**Re: Submission of Haldimand County Hydro Inc.
Board File No. : EB-2011-0027**

AND IN THE MATTER OF an application by Summerhaven Wind LP (the “Applicant”) for an order under section 92 and subsection 96(2) of the OEB Act granting leave to construct an electricity transmission line and related facilities.

SUBMISSIONS OF HALDIMAND COUNTY HYDRO INC.

NextEra - Summerhaven Proposed Transmission Line

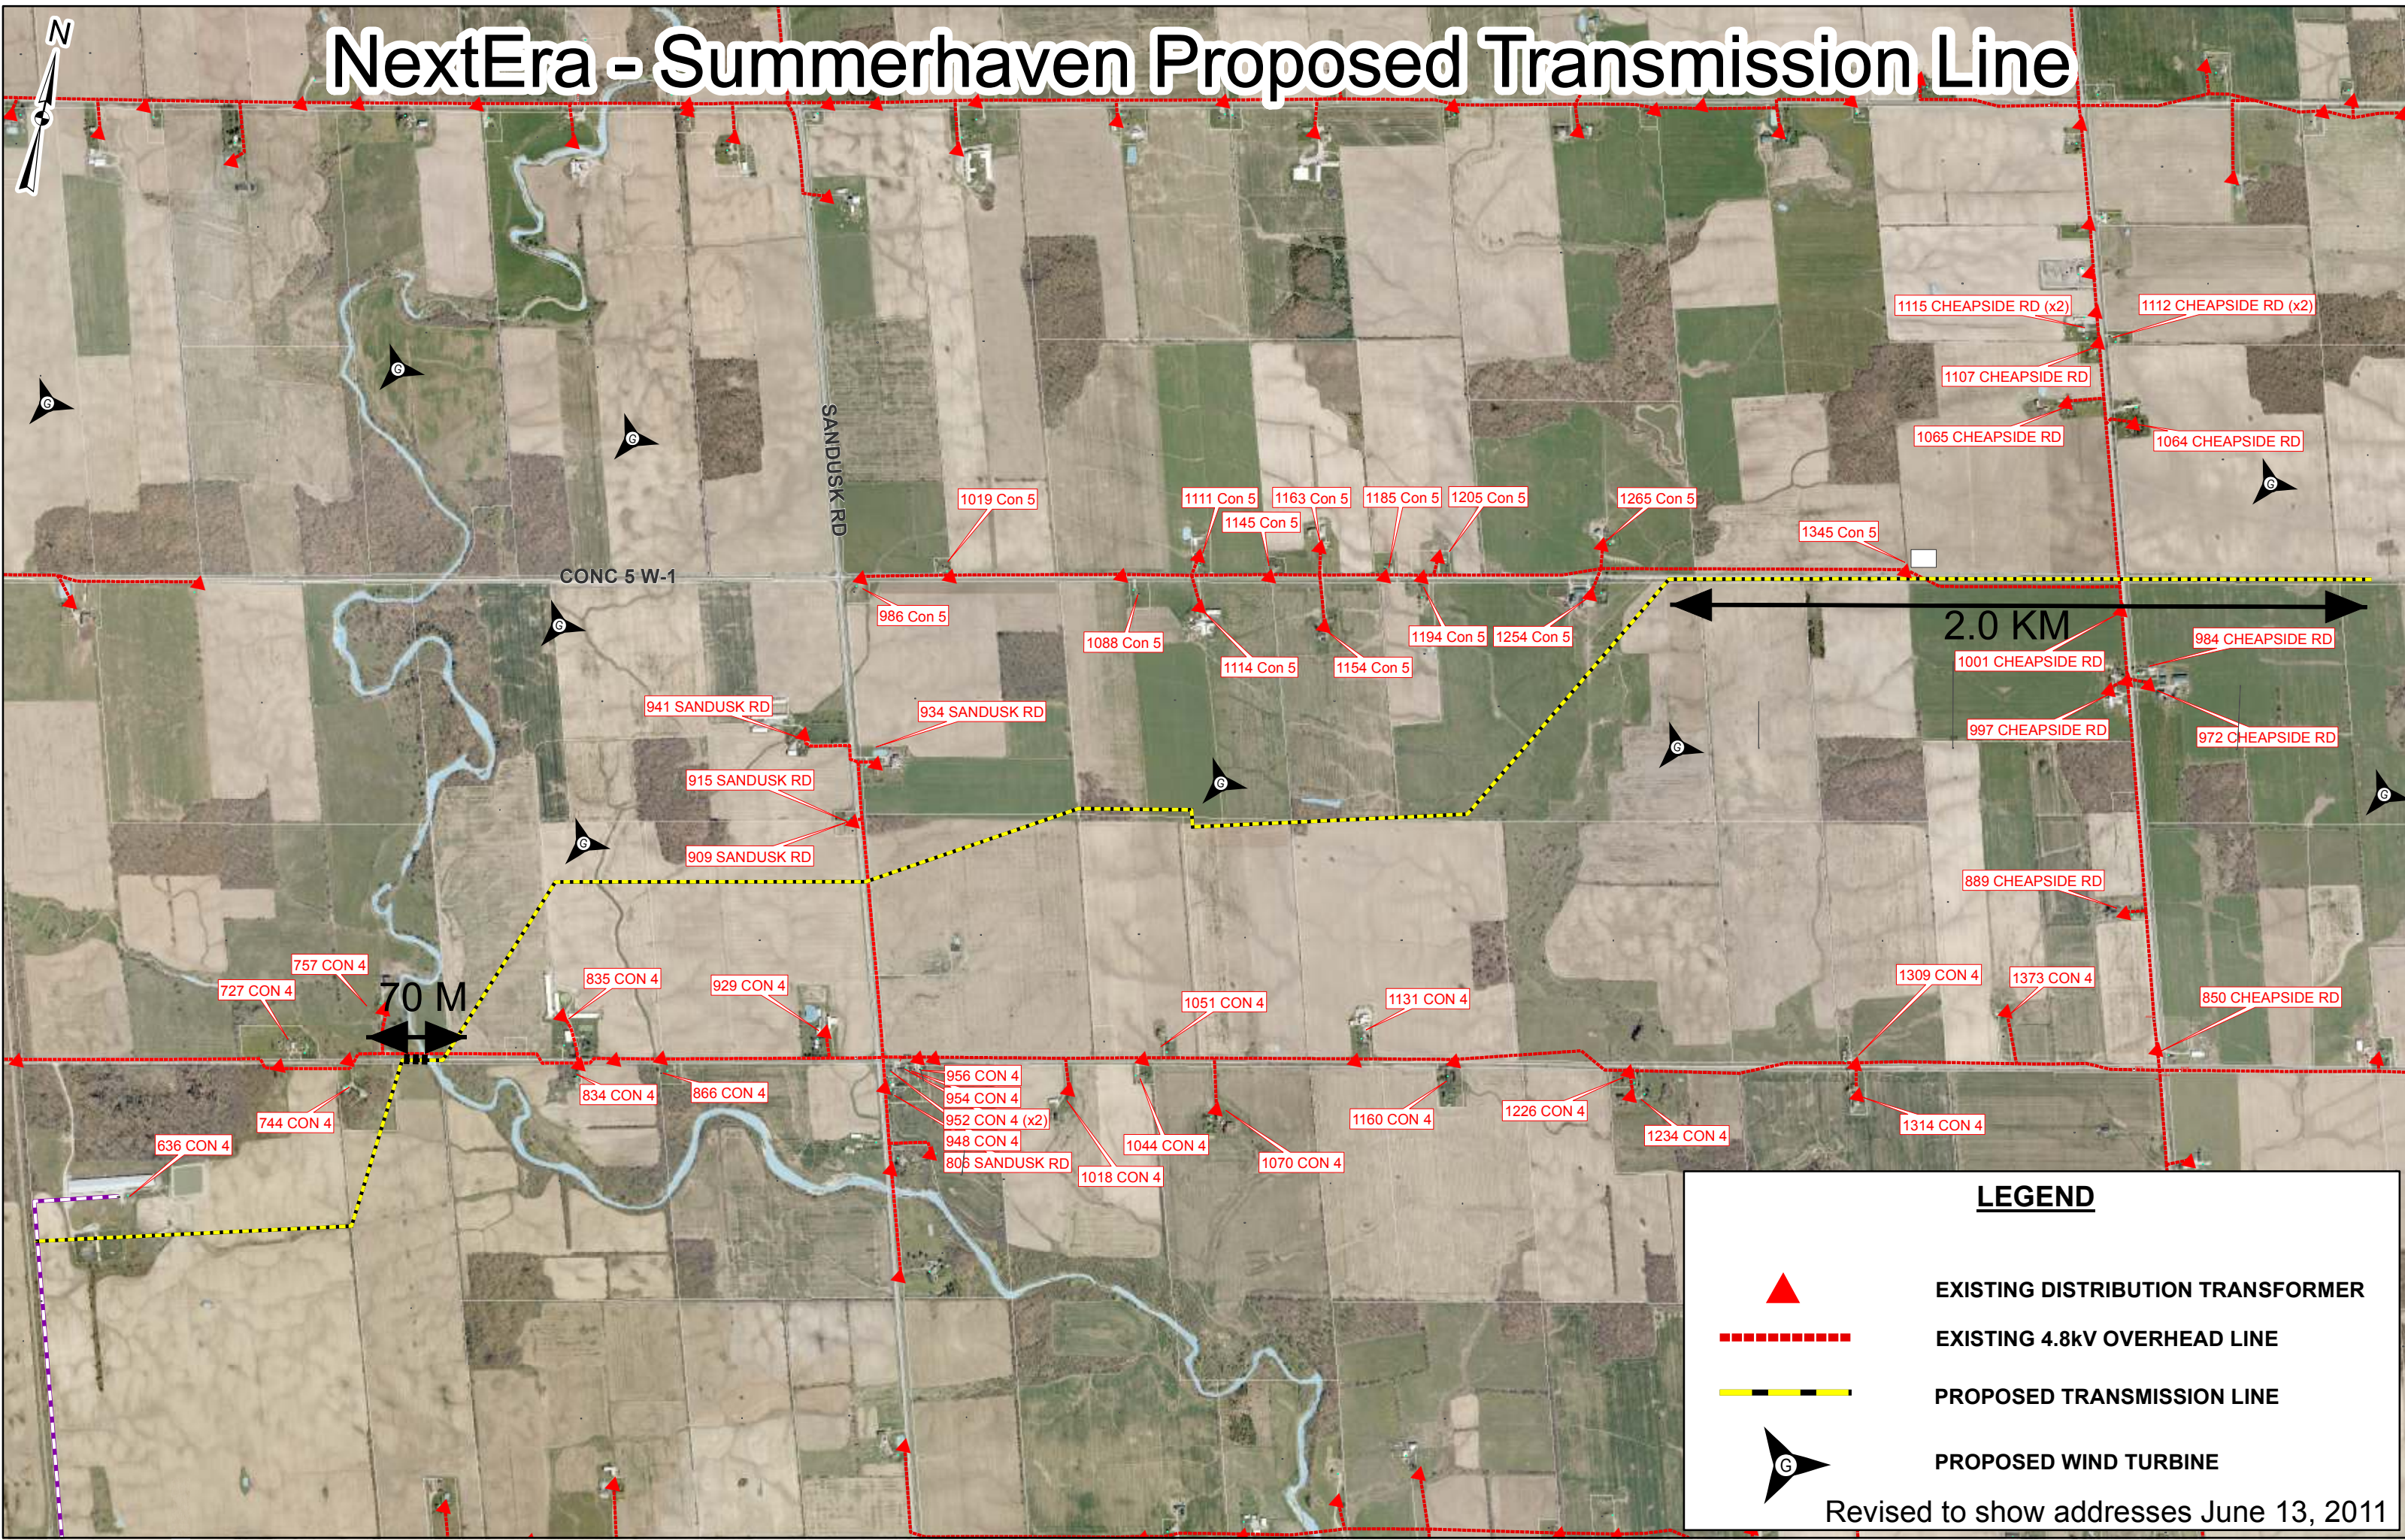
- 10) A map of the HCHI distribution system located in close proximity to the Project was filed during the Technical Conference, TCJ1.4. The map was updated as part of the response to interrogatories, Board Staff IR#3, and is appended to these submissions for ease of reference.
